# UNITED STATES PATENT AND TRADEMARK OFFICE

APPLICATION NO.	FILING DATE	FIRST NAMED INVENTOR	ATTORNEY DOCKET NO.	CONFIRMATION NO.
10/823,160	04/13/2004	Kiyokazu Ohtaki	27,702 USA	4547

## Office Action Summary

## DETAILED ACTION

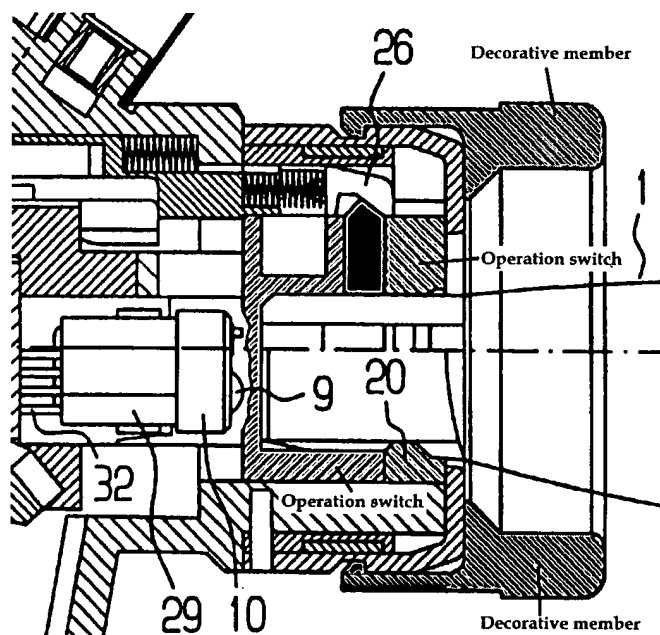
In an analogous art, Schweiger teaches a lock 7 that enables a vehicle's ignition (i.e., actuator) to be started (i.e., driven) when an ID code transmitted by key 1's transponder matches a predetermined ID code of the vehicle's control and evaluation unit 11 (see Col. 3, lines 56-67; Col. 4, lines 1-6 and 14-26; and Col. 6, lines 57-59). Schweiger's lock 7, as shown in Figs. 1-3,

includes (a) an operation switch, which includes receptacle 8 (see figure on the left) and is operated by an operator for starting the ignition (see Col. 3, lines 46-55; Col. 4, lines 4-67; and Col. 5, lines 1-7), (b) a decorative member (see figure on the left) surrounding the operation switch, and (c) communication means 29 spaced from the decorative member and formed by lock-side receiver 9 and lock-
